Date: 10/25/2022
RFP No: 2022-084
Commodity: Cameron Park Zoo Education Center & Vet Hospital
Purchasing Agent: Mr. Kasey Gamblin

Addendum No: 1

Addendum #1

Project Name: Cameron Park Zoo: Education Center & Vet Hospital

C1.1

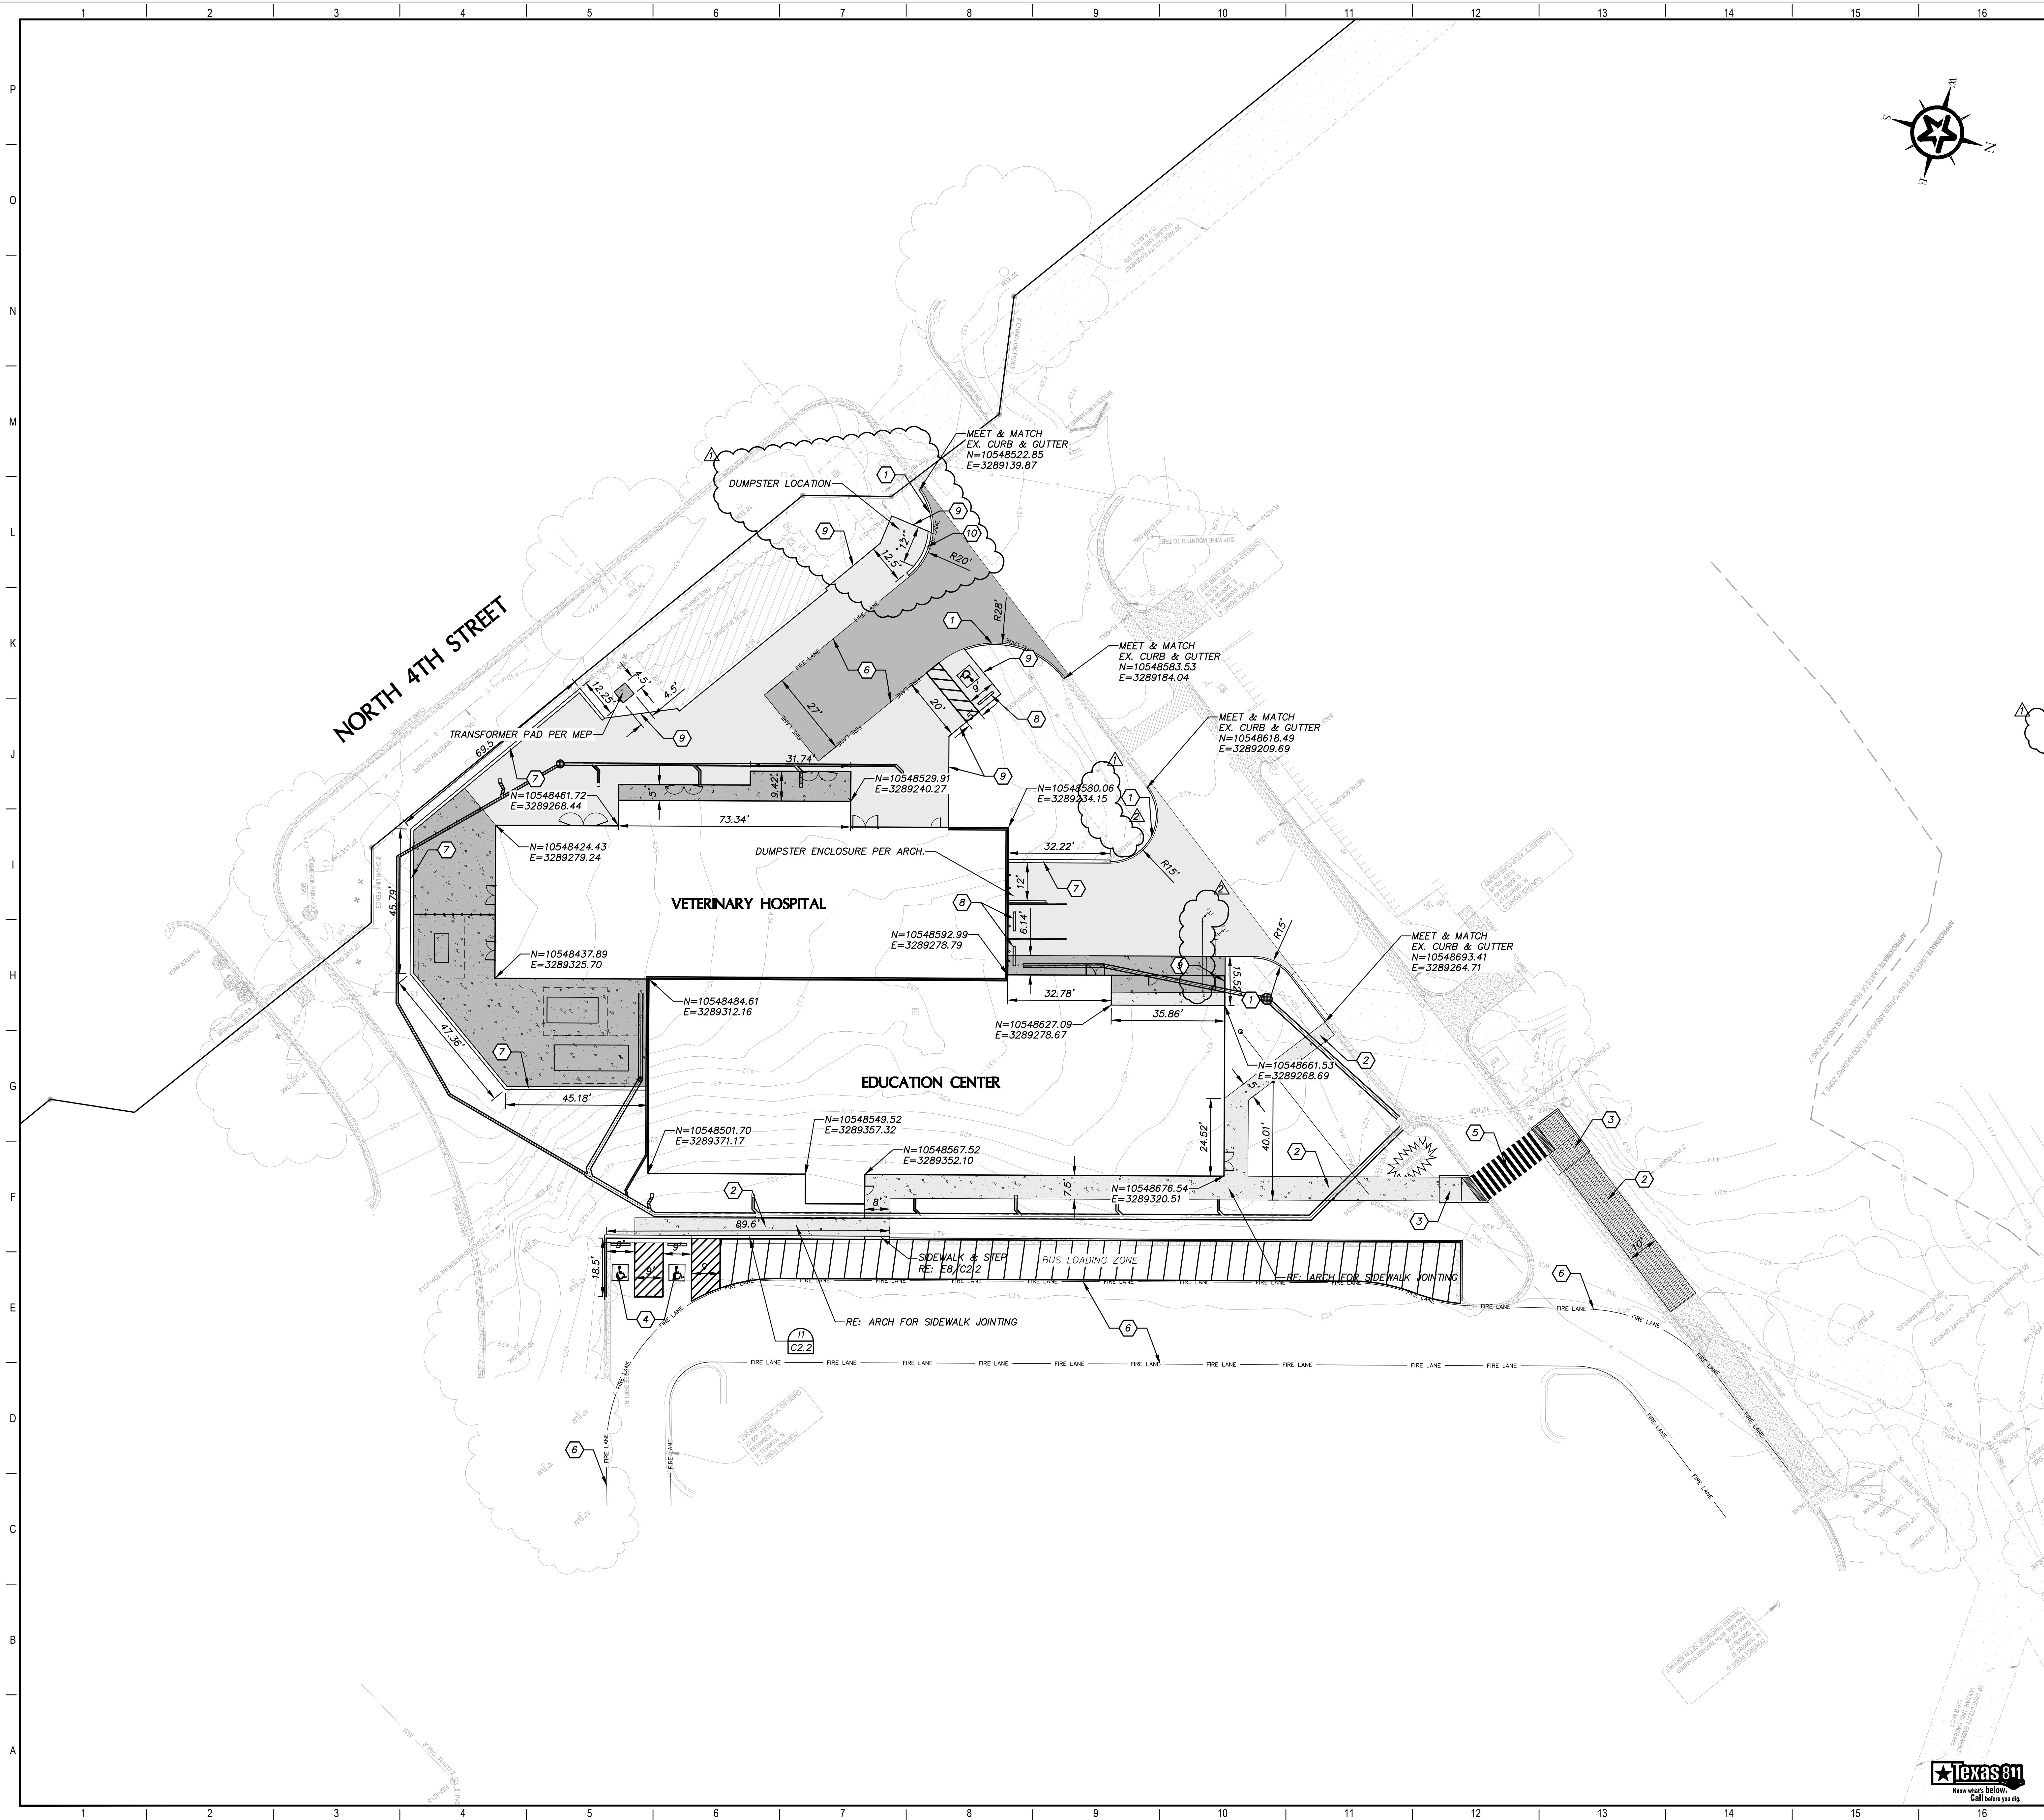
C1.1: Domestic water meter vault removed from scope of project

UTILITY PLAN

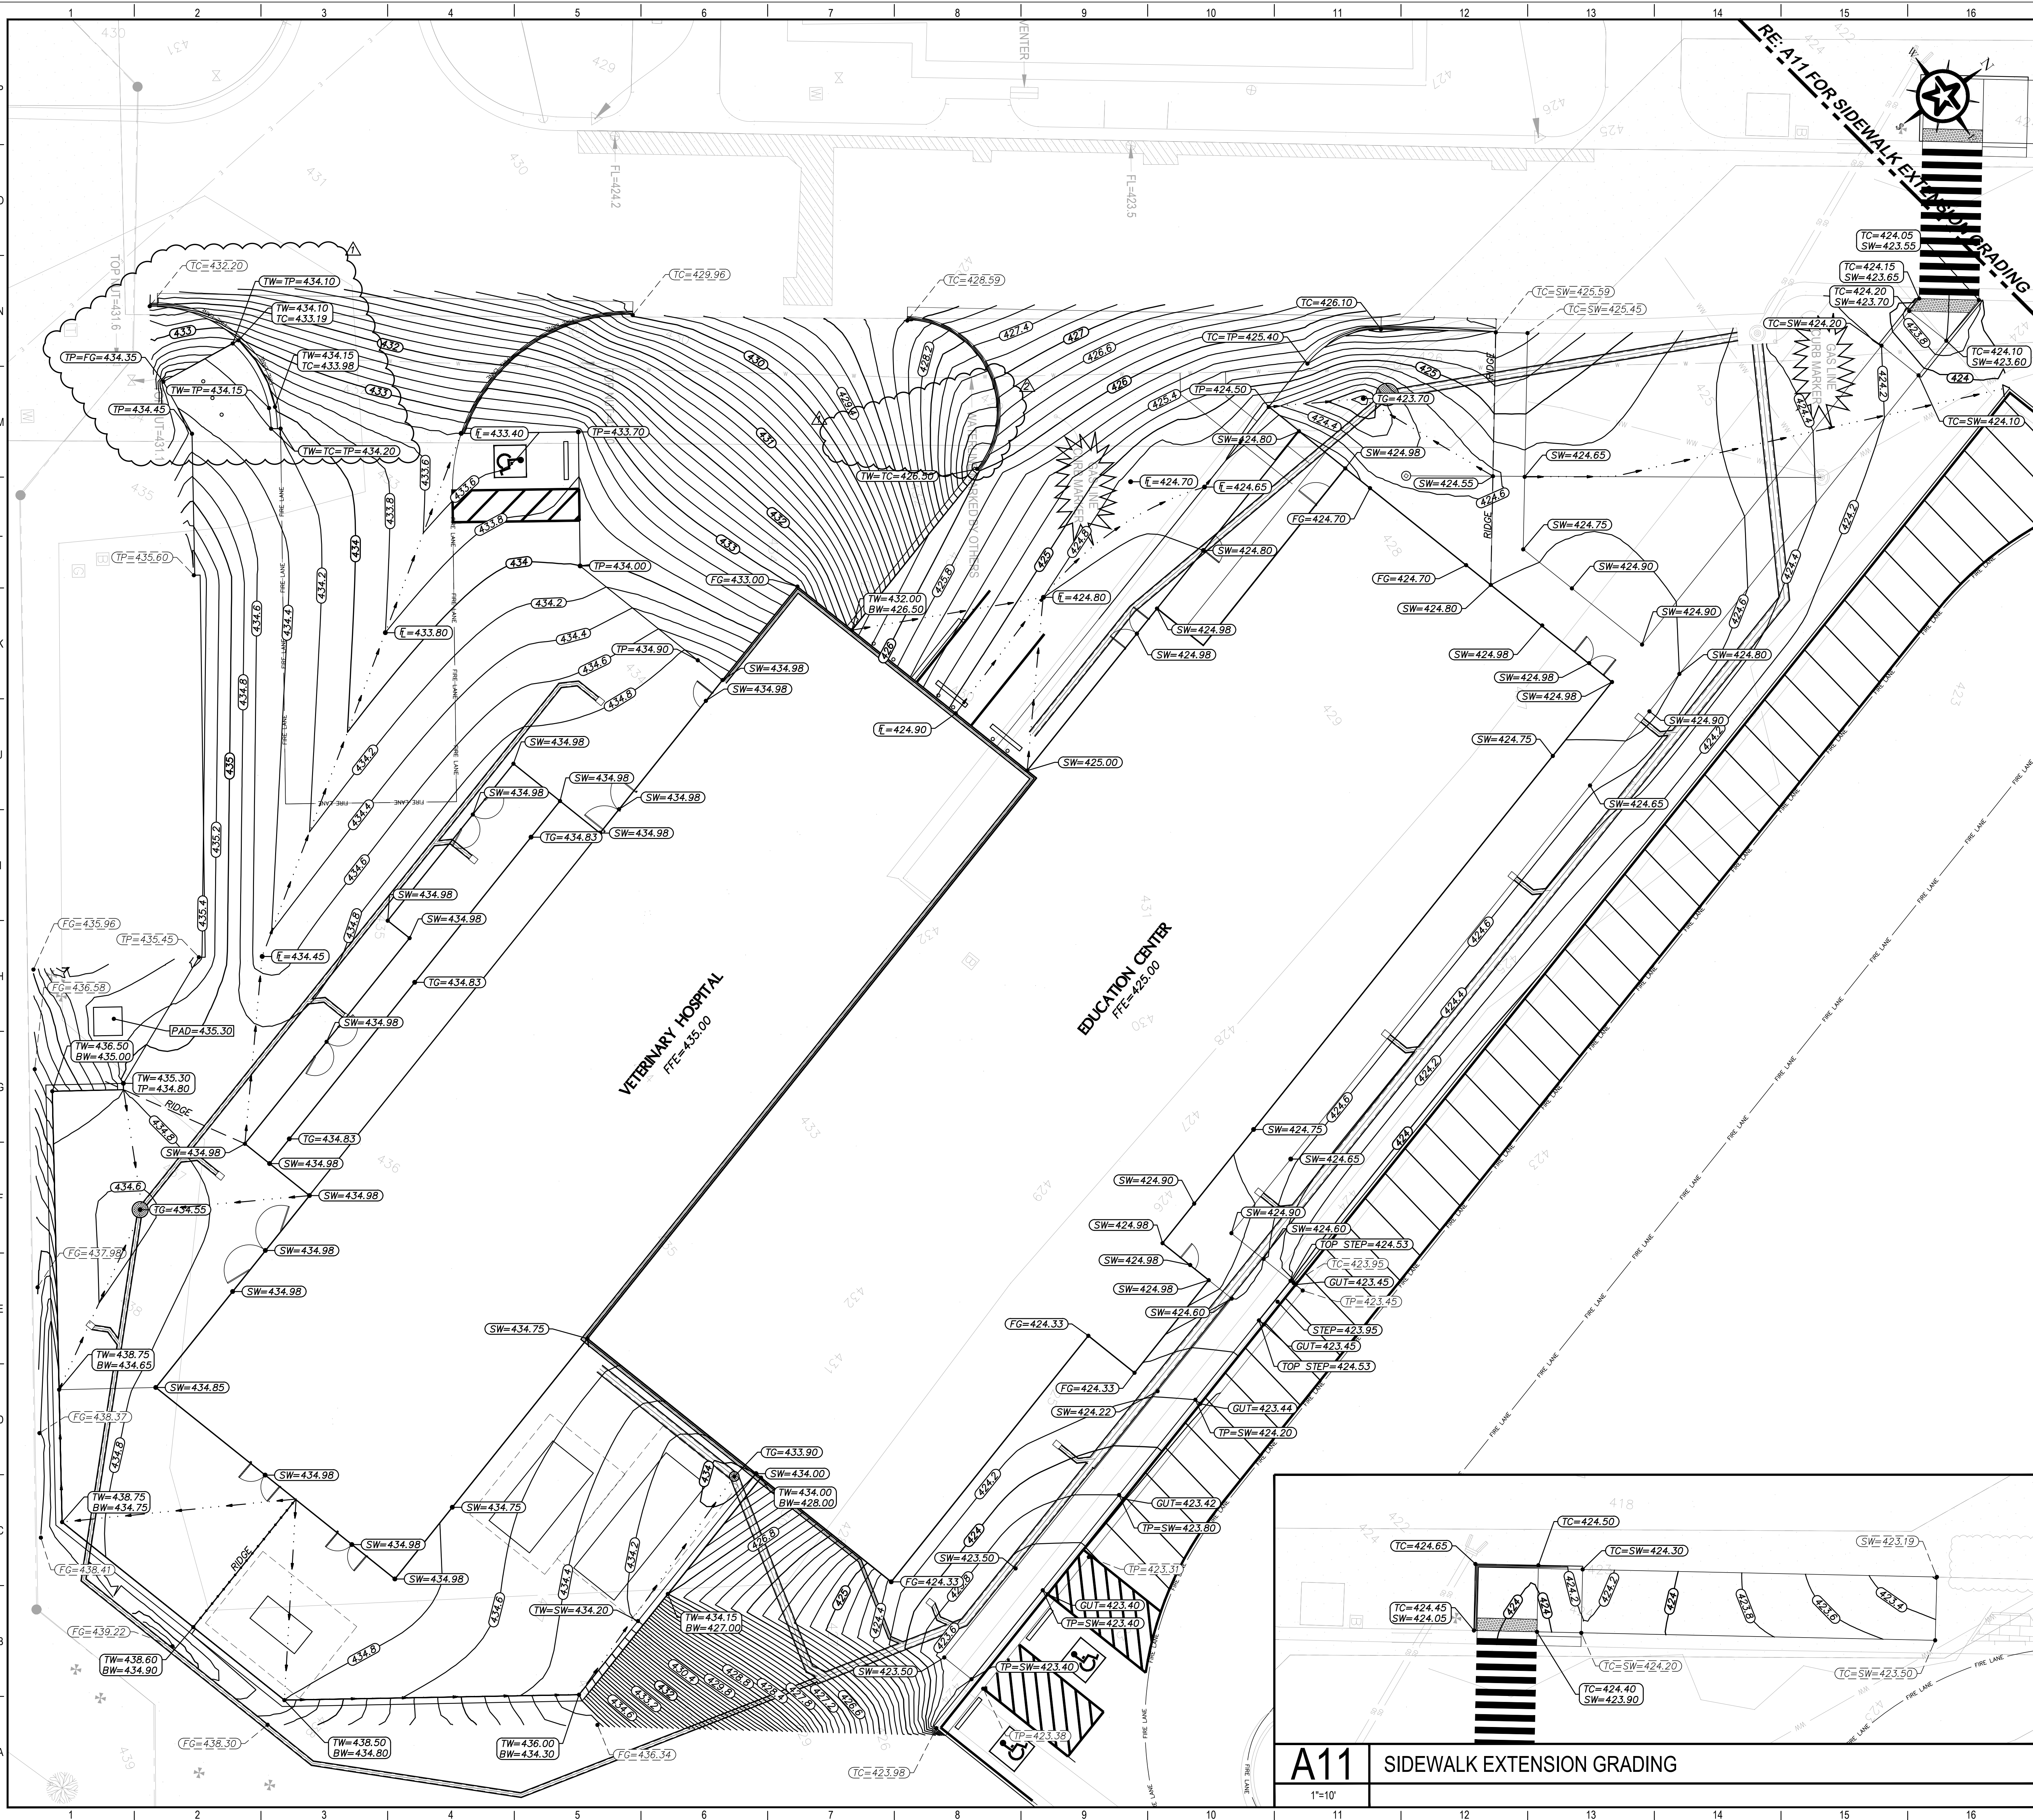
C2.1: Domestic water meter vault removed from scope of project

A01-01

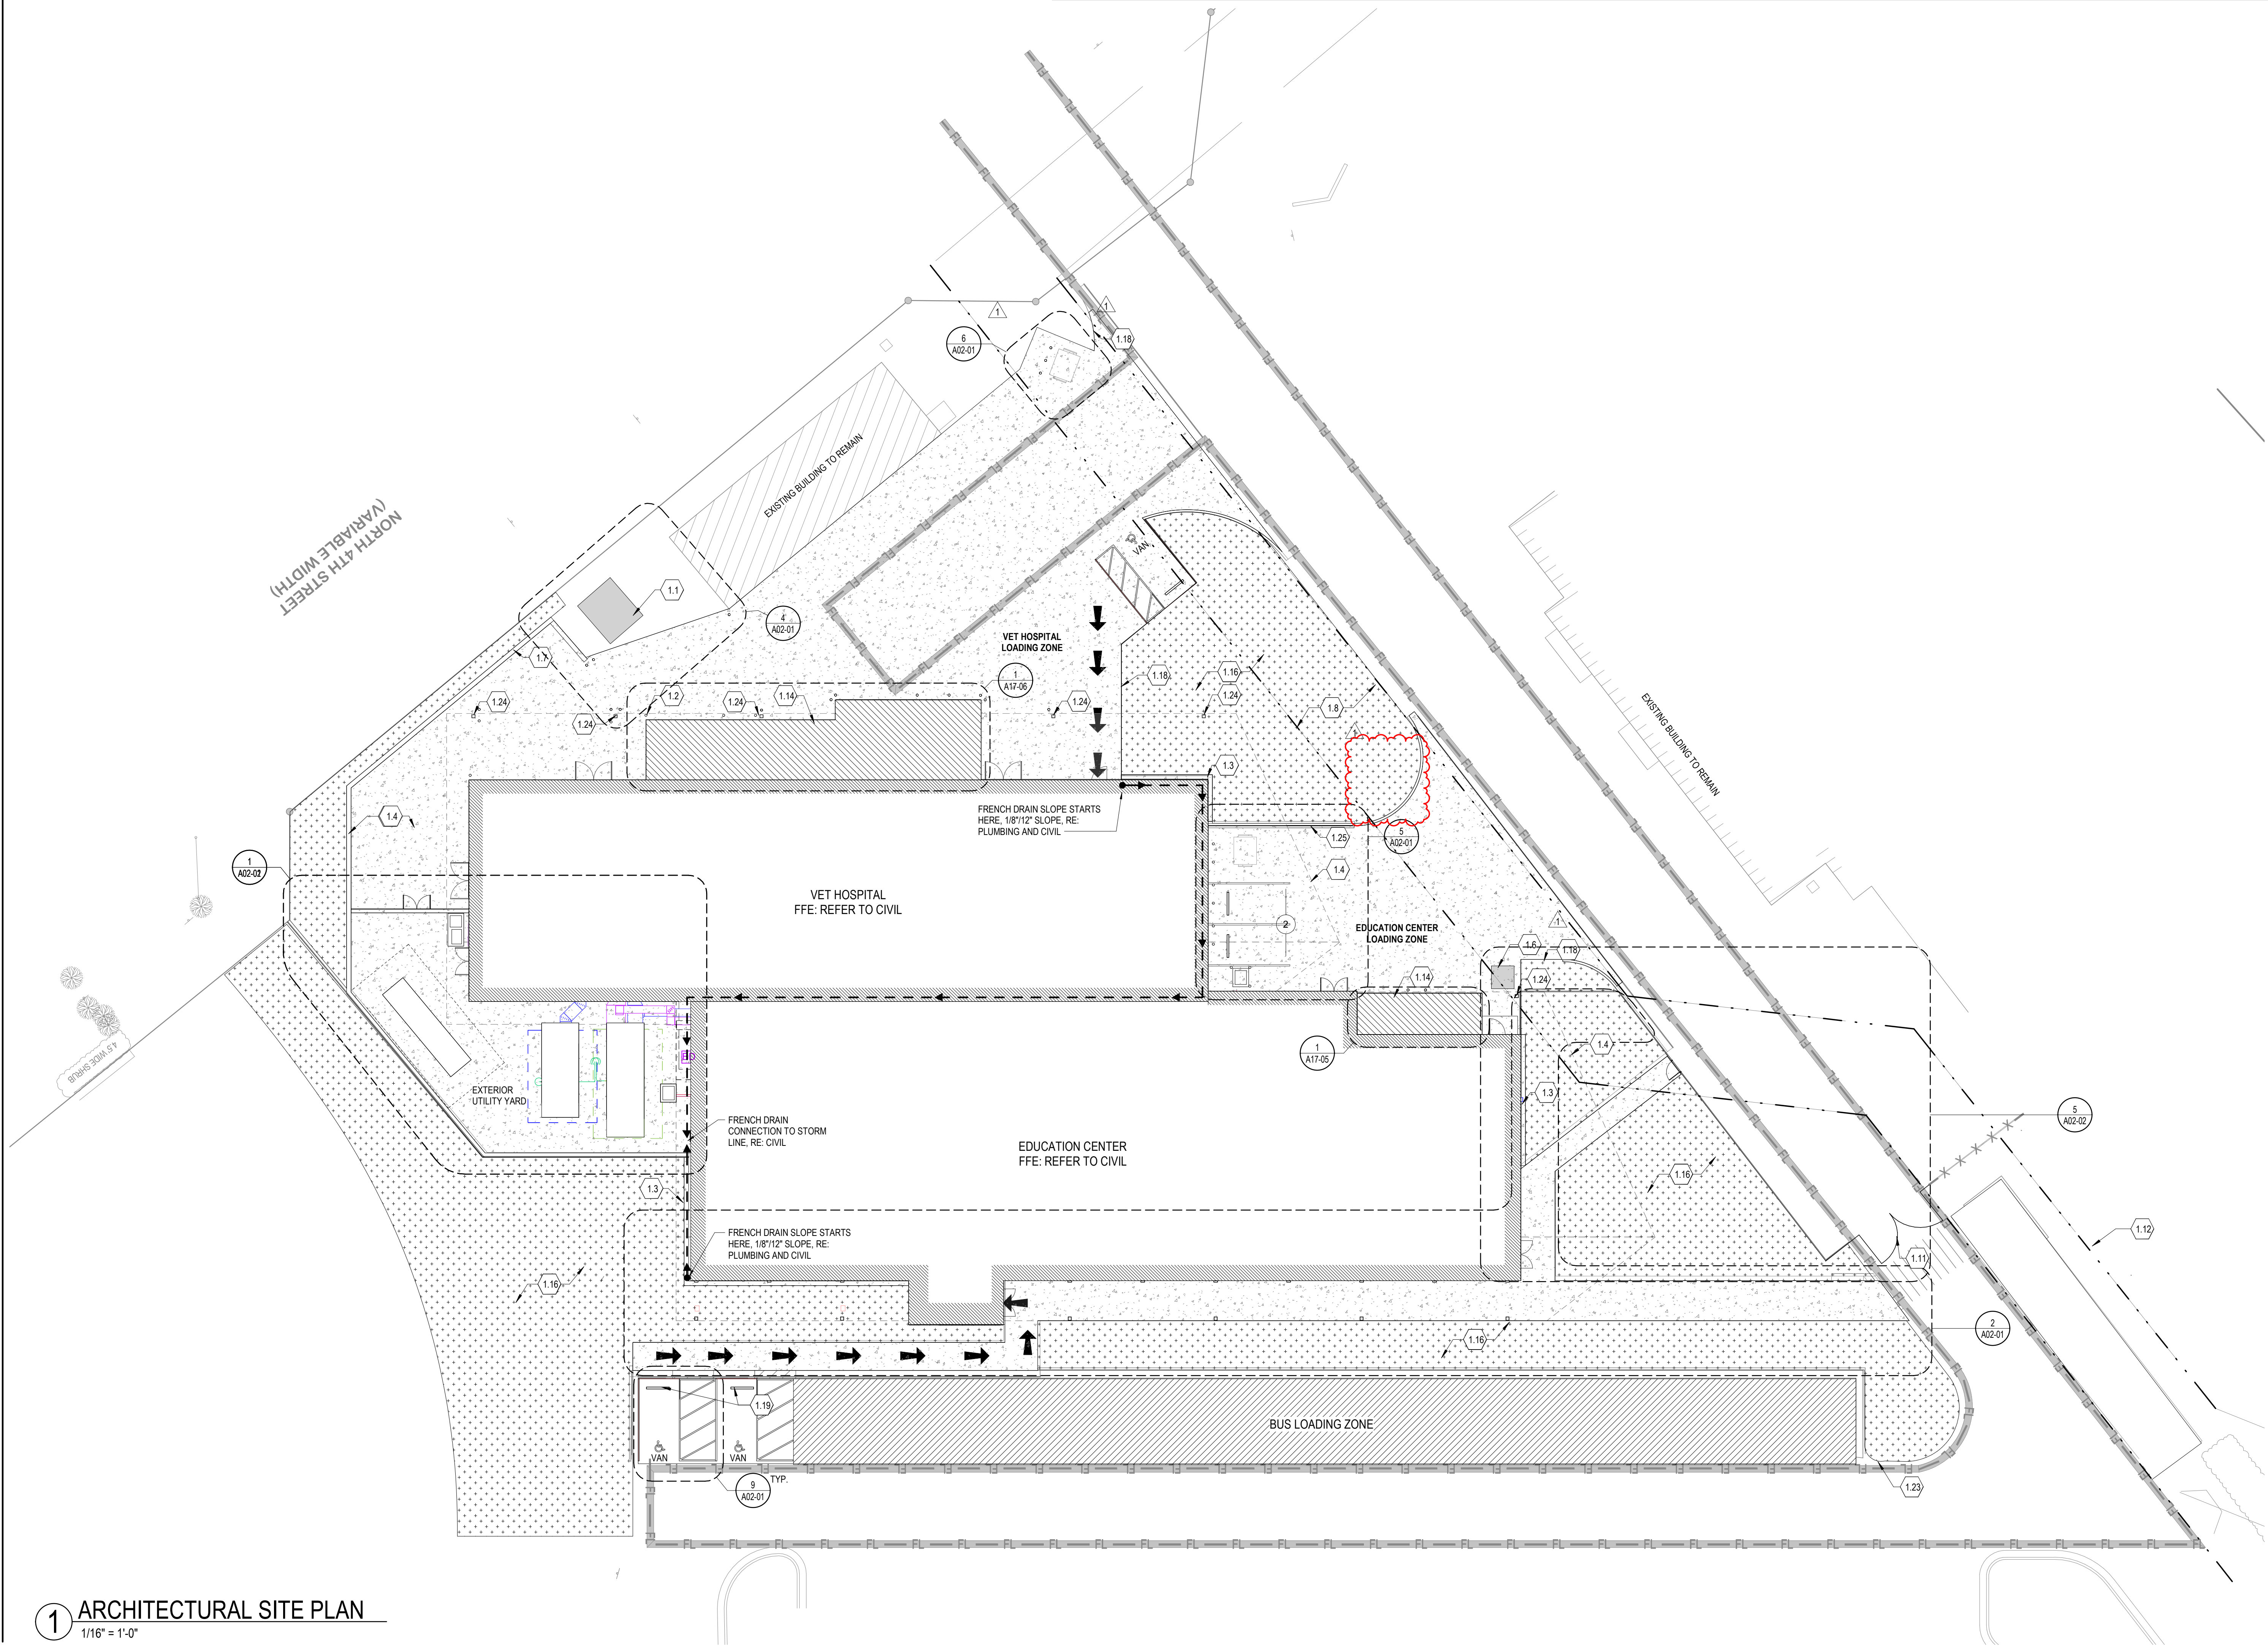
A01-01: Domestic water meter vault removed from scope of project
